A319/A320/A321

SERVICE BULLETIN
REVISION TRANSMITTAL SHEET

TITLE : AIR CONDITIONING - INSPECT PACK RAM AIR INLETS

This page transmits Revision No. 02 of Service Bulletin No. A320-21-1062.

Inspection of the Ram Air Inlet
Figure 2 Sheet 1

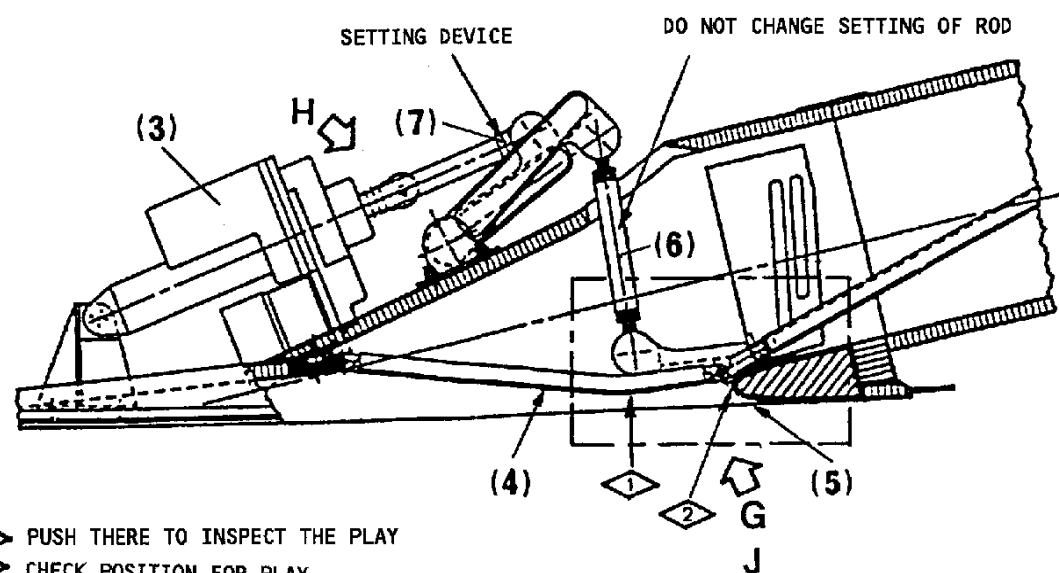
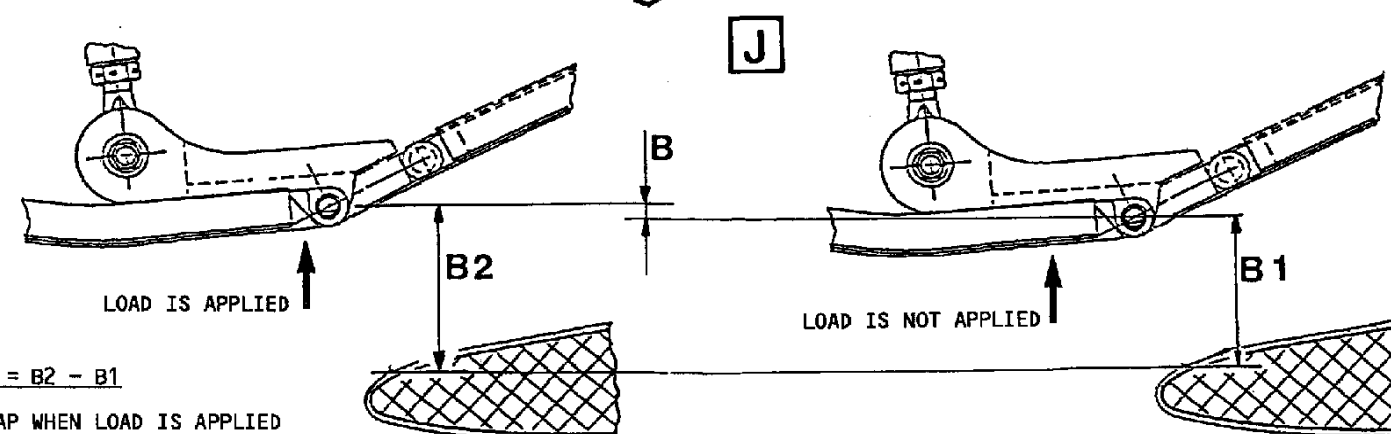
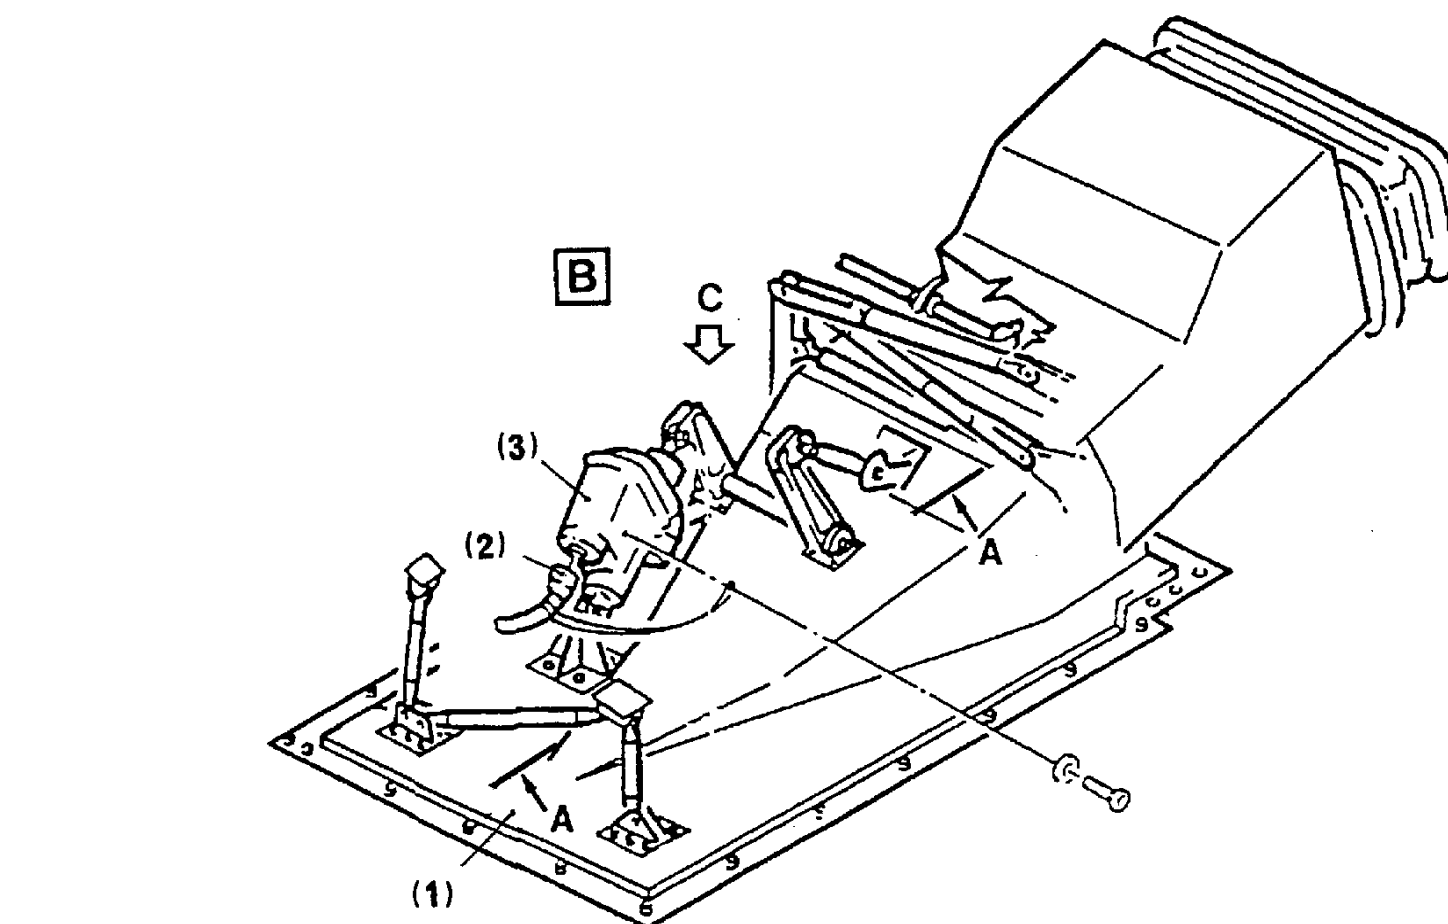
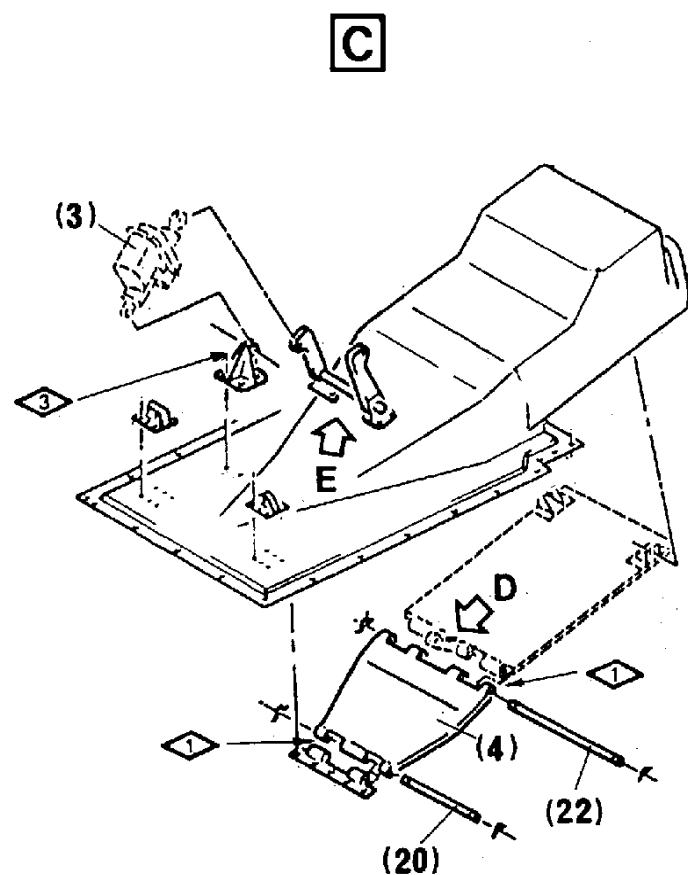
- Para. B.(1)(a), Brackets added to items.
- Para. B.(1)(a)1 thru 6, Brackets added to items.
- Para. B.(2), Brackets added to items.
- Para. B.(2)(a) thru (c), Brackets added to items.
- Para. B.(3), Brackets added to items.
- Para. B.(3)(a)1 and 2, Brackets added to items.
- Para. B.(3)(b) and (d), Brackets added to items.
- Para. B.(5)(a), Brackets added to items.
- Para. D.(1), Sentence amended.
- Para. D.(2), Sentence added.
- Figure 2, Brackets added to items.
- Figure 3, Brackets added to items.

(a) Try to move the diffuser ramp, item (4), by hand at position shown in Figure 2, Sheet 1, section A-A and check the play:

- 1 Measure the play 'B' (gap B2 minus gap B1) between the flaps and intake nose as shown in detail J, refer to Figure 2, Sheet 1.
- 2 If the play is less than 1mm (0.039in.), repeat this Inspection Service Bulletin at the next fourth A-check.

- 3 If the play is between 1mm (0.039in.) and 3mm (0.118in.), inspect the gap dimension between the intake nose and the diffuser ramp (Ref. Para. B.(3)).

- 4 If the play is more than 3mm (0.118in.), check the following connections (at items); if necessary disconnect the lever, item (15), at the electrical actuator and retain the bushes, item (10), and fastening parts:
